Meeting of the Village of Buffalo Grove Planning and Zoning Commission

**Regular Meeting
October 6, 2021 at 7:30 PM**

**VILLAGE OF BUFFALO GROVE
PLANNING & ZONING COMMISSION
STAFF REPORT**

**VILLAGE OF BUFFALO GROVE
PLANNING & ZONING COMMISSION
STAFF REPORT**

MEMORANDUM

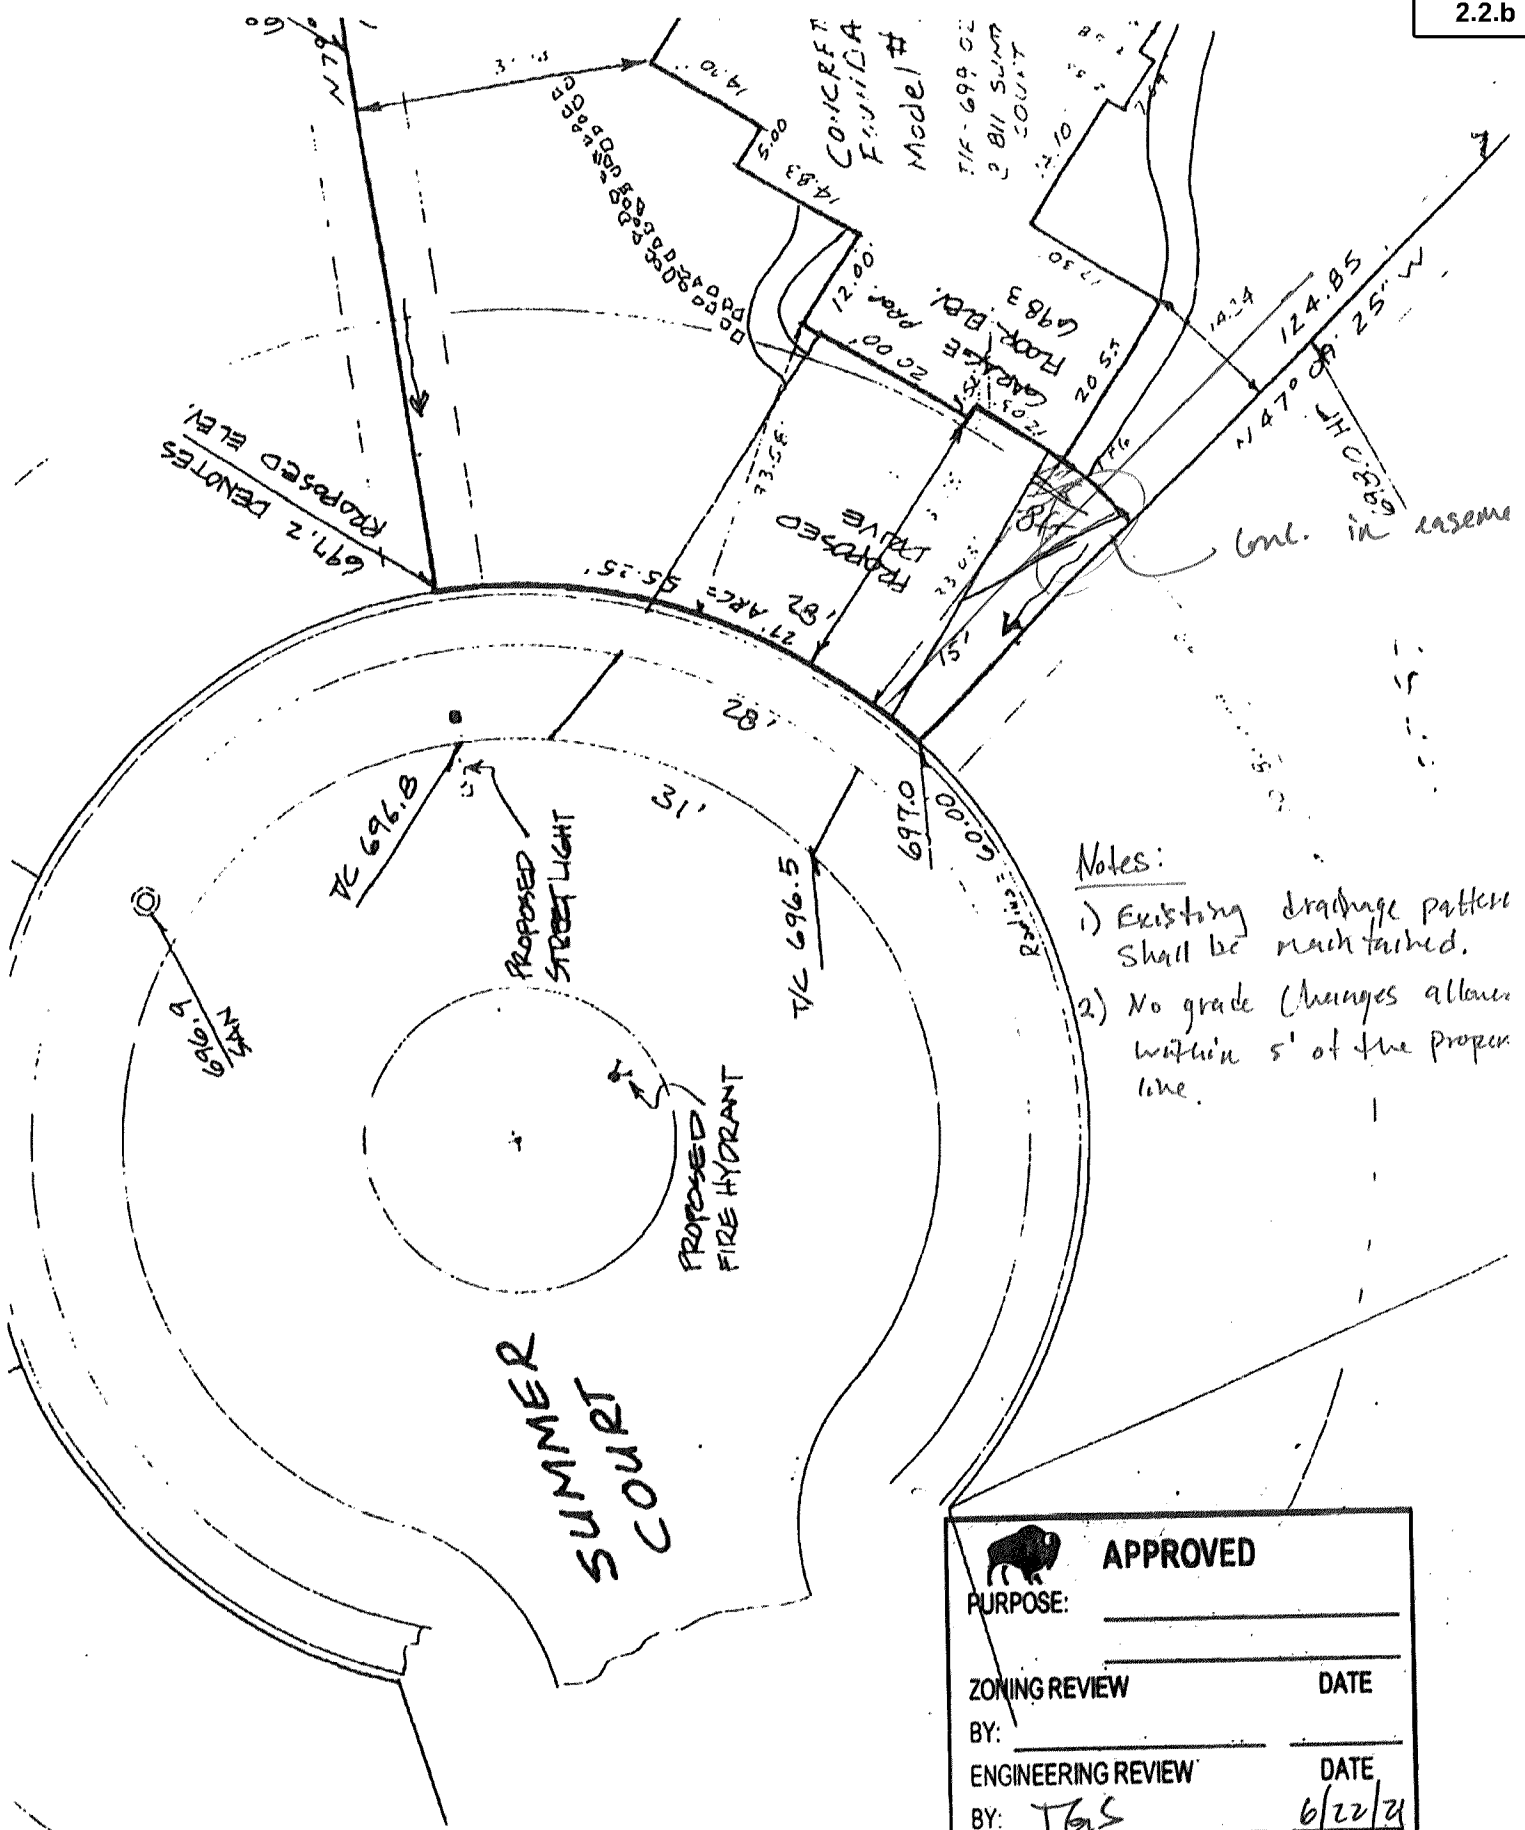
The Engineering Department received a request to inspect/verify grading for a driveway extension adjacent to the driveway serving 811 Summer Court. This work was performed without a permit and permitted post construction. Upon inspection, the newly poured concrete does not comply with Village code. The driveway extension has slightly raised the grade through a portion of the property where a drainage easement exists. There are three scenarios available to rectify this issue. The homeowner at 811 Summer Court may:

1. The plat that was submitted with the permit post construction which shows the Engineering Department comments for the work, and a circled area where the new concrete does not meet Village Code.
2. A picture illustrating the grade change.
3. Aerial pictures illustrating additional unpermitted fence replacement.

1. Remove the portion of concrete driveway extension within the easement and regrade adjacent to the remaining concrete;
2. Remove the new concrete in its entirety; or
3. Replace the concrete within the easement, lowering the new concrete to meet the previously existing grade.

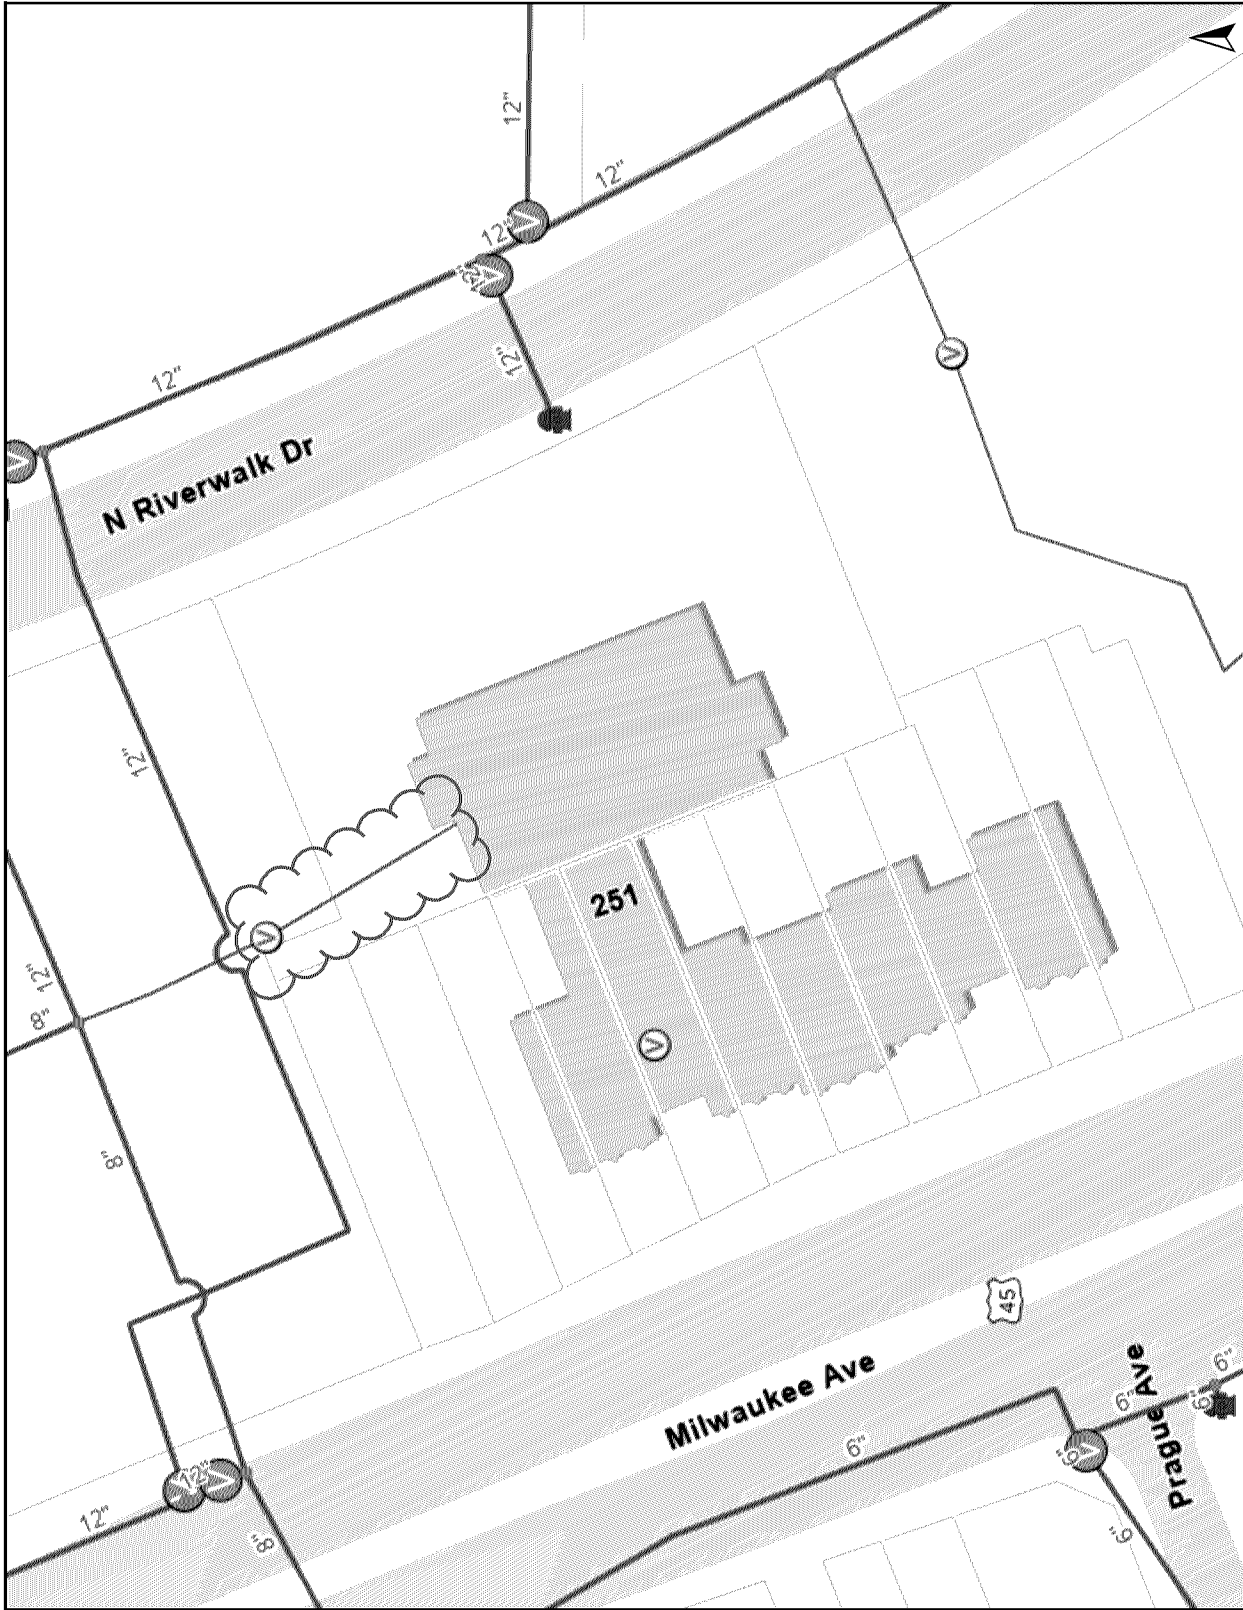
1. The building being demolished at 251 N. Milwaukee is believed to have one Village water connection and one private water well. If the water well still exists, it will need to be properly abandoned.
2. Enclosed is the Village's GIS record of the location of the water service connection to building 251 N. Milwaukee. This may not be the actual location; however, no water services are shown on the demo plan for the 251 building. Please add removal of the water service to the demo plan.

1. SE/SC will be required on the west side of IL-21. Not sure if you were going to show on this set of plans, or offsite plans.
2. Add inlet protection to the storm structures along Riverwalk Drive immediately south of the proposed Riverwalk Drive construction entrance.
3. Both CE sheets drawing no.'s are CE. Please update the drawing no. on the second sheet to CE1.
4. The concrete washout detail is very faint on sheet CE1.

1. Two consecutive sanitary sewer cleanouts are not allowed per code. If one clean out is insufficient, please add another sanitary structure.
2. Crossing X1 has 4" of separation between pipes. Have pipe material thicknesses been accounted for?
3. Please replace the existing storm inlet at the NE speedway entrance with a catch basin.
4. Pipe crossing X7 shall be placed in casing or WMQ pipe utilized for the storm sewer.
5. Are the ADS inlet filters shown on page CU1 permanent or to be utilized for SE/SC purposes?
6. If an irrigation system is incorporated into the project, a separate Building Department permit will be required prior to system installation.
7. Maximum structure riser ring height allowed is 2 courses at 6". Please update details on CUD-1.
8. Eliminate the last five rows of pipe specifications on CUD-1.

1. Please remove the cold weather curb installation detail.
2. Update pavement berm detail to show 3:1 max slope.

1. Please confirm use of the ISWS Bulletin 75 rainfall data.
2. It appears Area 11 and 12 do not connect to the proposed detention basin. How is this unrestricted flow accounted for?
3. It appears storm sewers 2-5 surcharge during the 10-year event. Please size these accordingly to convey the 10-year storm within the pipe.
